Comment Set F4 – Southern California Edison

Southern California Edison's West of Devers Upgrade Project Additional Material Yard Environmental Review

Responses to SCE Comments Related to Project Description Changes (Comment Set F4)

Figure B-7b
 Existing and Proposed
 Corridor Profile - Segment 6

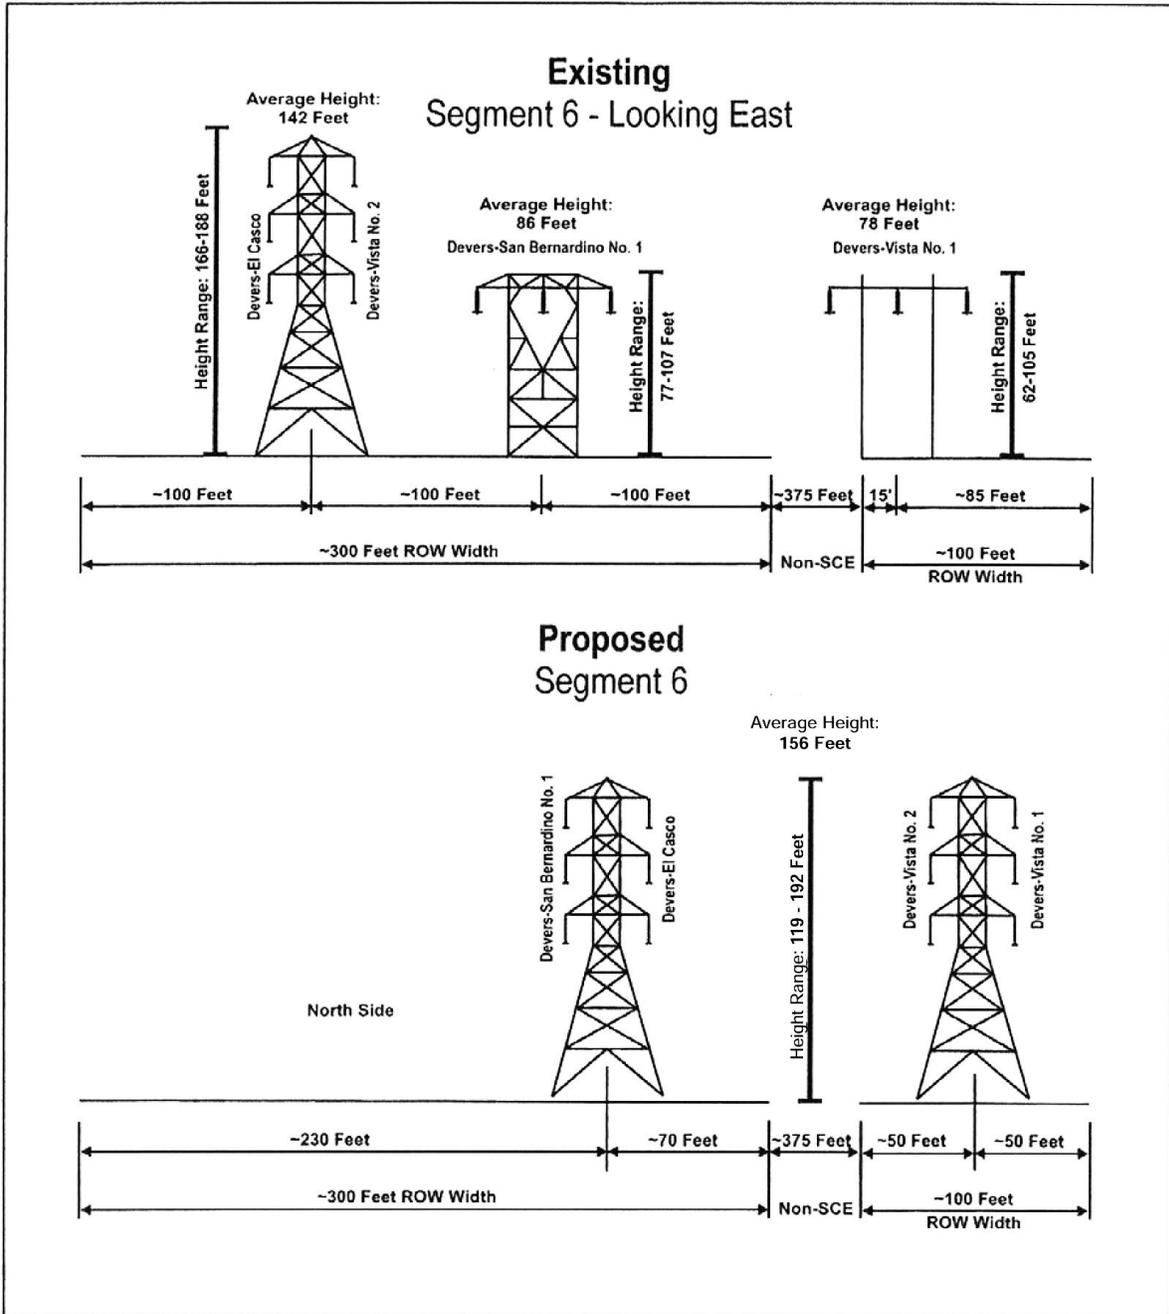
F4-4
 cont.

- Figure B-2b (Existing and Proposed Corridor Profile – Segment 1),
- Figure B-3b (Existing and Proposed Corridor Profile – Segment 2),
- Figure B-4b (Existing and Proposed Corridor Profile – Segment 3),
- Figure B-5b (Existing and Proposed Corridor Profile – Segment 4),
- Figure B-6b (Existing and Proposed Corridor Profile – Segment 5),
- Figure B-6c (Existing and Proposed Corridor Profile – Segment 5), and
- Figure B-7b (Existing and Proposed Corridor Profile – Segment 6).

Figure B-10
 Typical 220 kV
 Transmission Structures

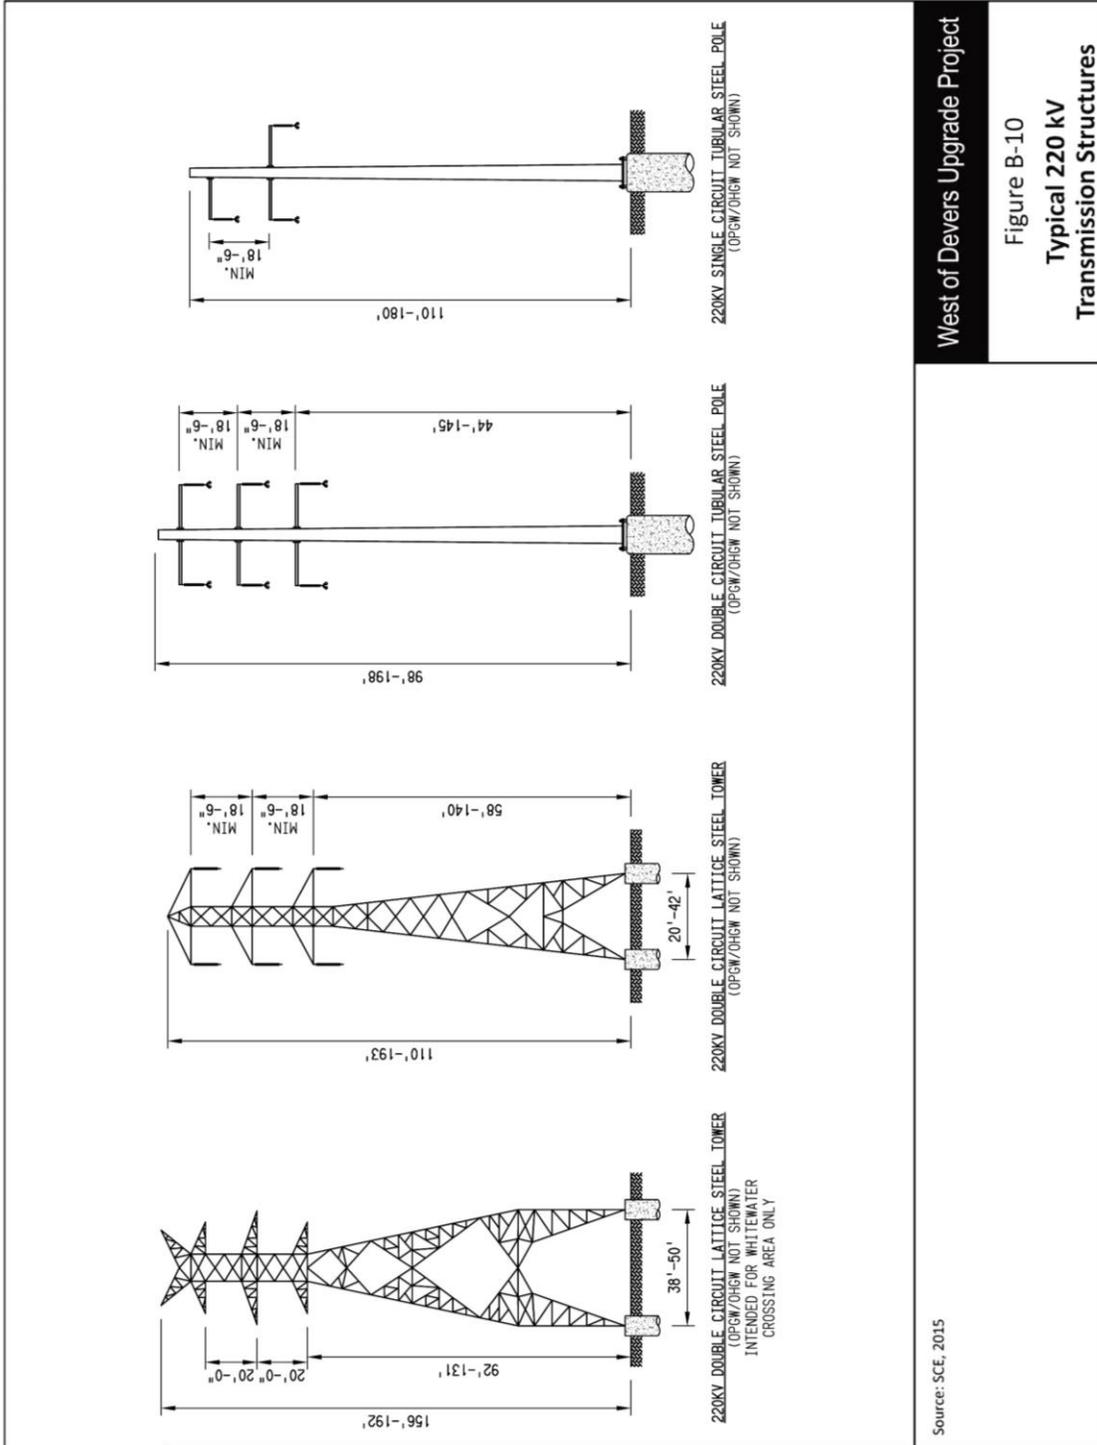
F4-5

F4-5 The commenter has provided a revised Figure B-10 (Typical 220 kV Transmission Structures). Therefore, Figure B-10 has been updated in Section B (Description of the Proposed Project) of the Final EIS, as also addressed in Response to Comment F3-84.
